**U.S. NUCLEAR REGULATORY COMMISSION  
Office of Nuclear Material Safety and Safeguards  
Spent Fuel Project Office**

**CONFIRMATORY ACTION LETTER 97-7-001  
TECHNICAL EVALUATION**

Docket No. 72-1007

Certificate Holder: Sierra Nuclear Corporation  
One Victor Square  
Scotts Valley, CA 95066

Figure A1

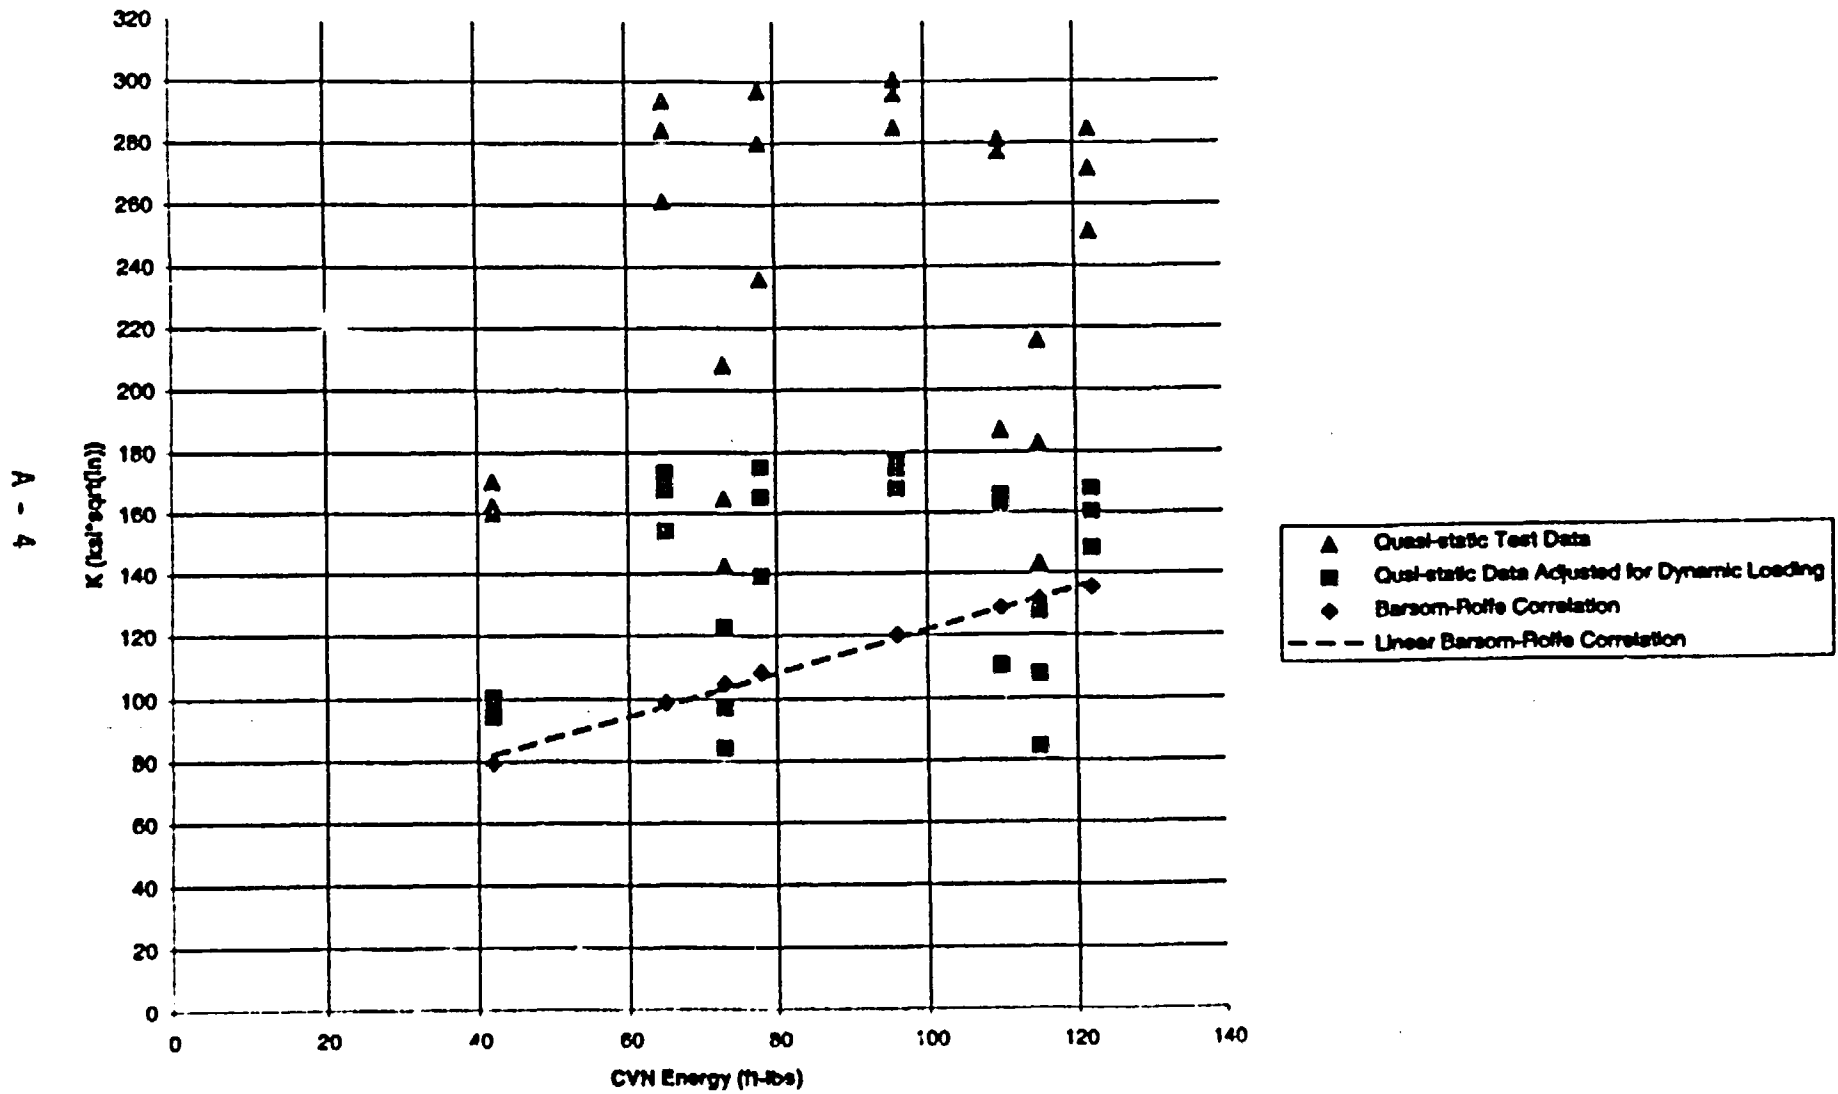
The staff plotted the data for fracture toughness and CVN provided by the Owners Group (Figure A1). The staff did not observe any relationship between  $K_{Ic}$  and CVN in the data presented and concluded that the Barsom-Rolfe correlation for the MSB material was inappropriate. This staff position was documented in the May 21, 1998, letter from NRC to SNC.

In its independent evaluation, the NRC staff considered fracture toughness data generated by both the Owners Group and NSWC and used the following approach to arrive at a limiting fracture toughness of 53 ksi $\sqrt{\text{in}}$  for a temperature of 0°F:

Figure B1

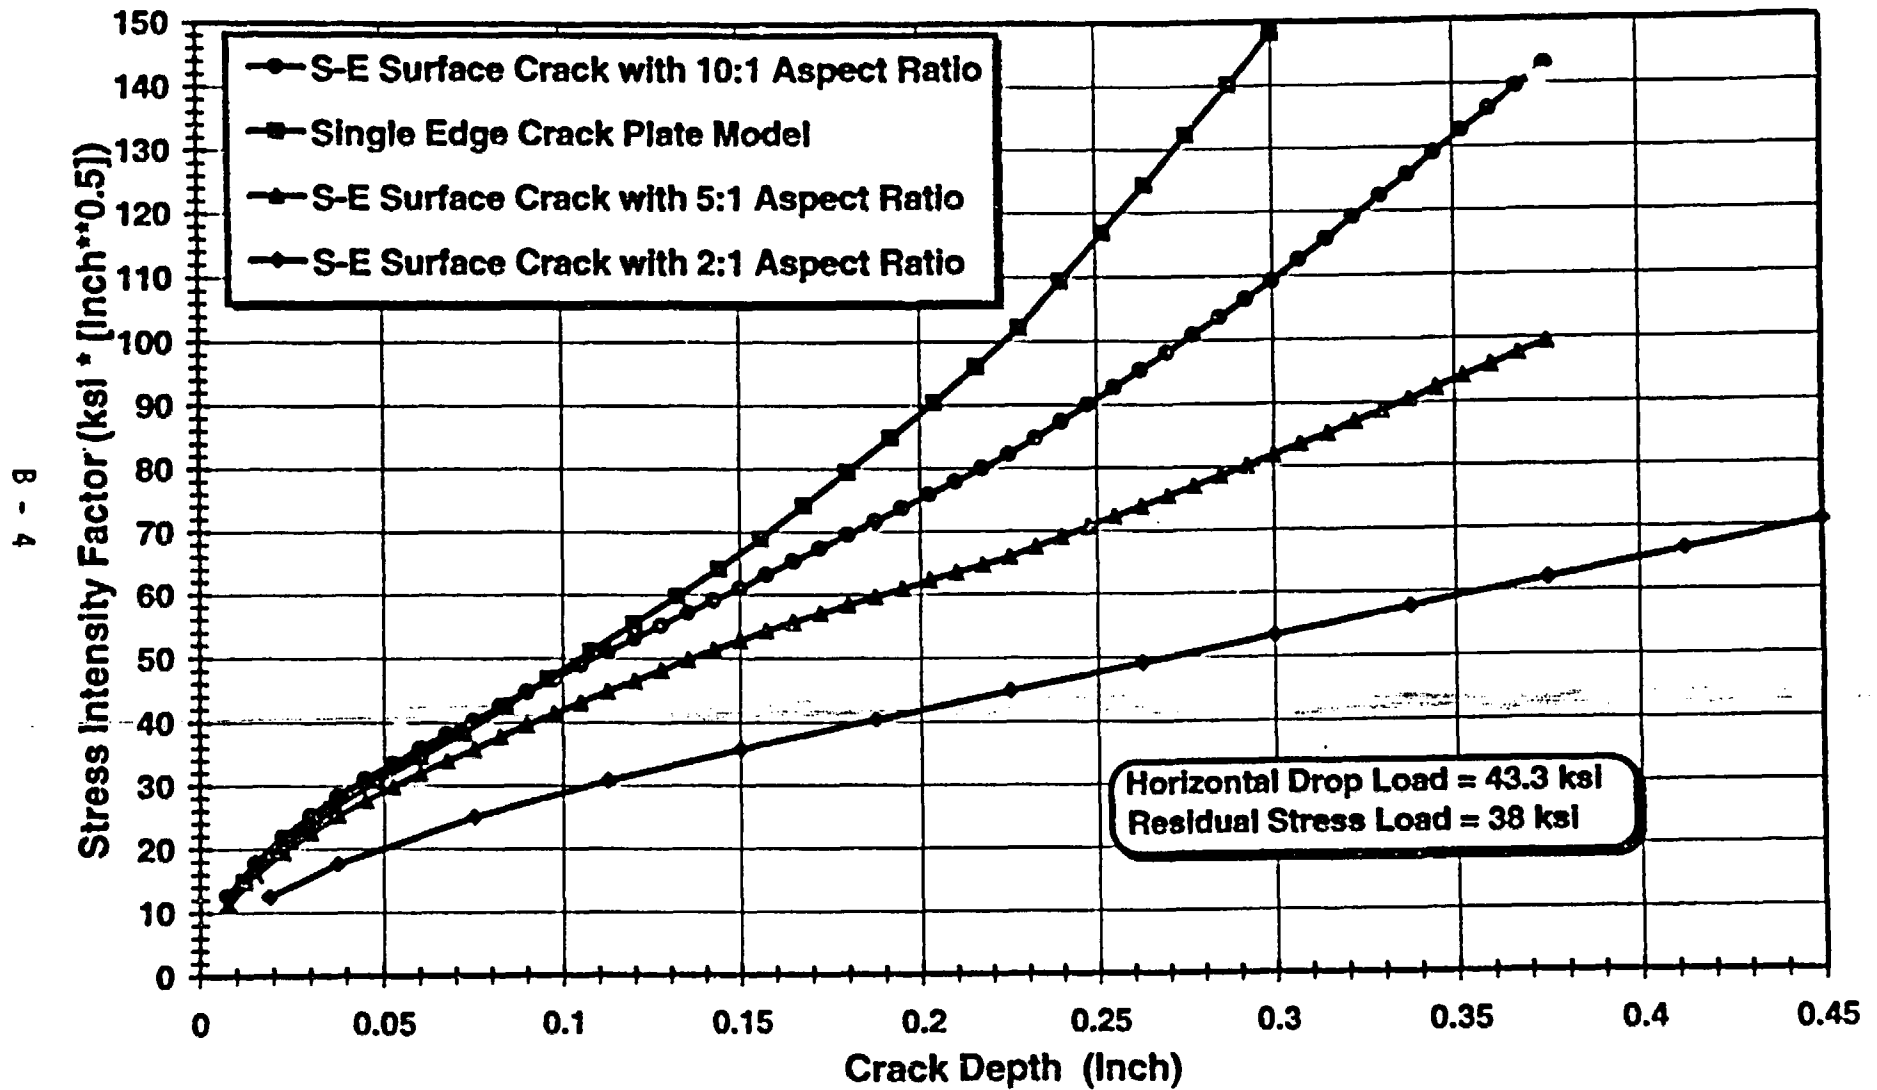
Figure B1 shows the maximum stress intensity factors ( $K_I$ ) for the semi-elliptical cracks with aspect ratios,  $a/c$ , of 0.5, 0.2, 0.1 and 0 SECP, as a function of the crack depth. It can be seen that as the aspect ratio,  $a/c$ , value decreases from 0.5 to 0, the crack driving force ( $K_I$ ) values increase with the SECP (i.e., for  $a/c = 0$ ) being the highest value for any given crack depth.
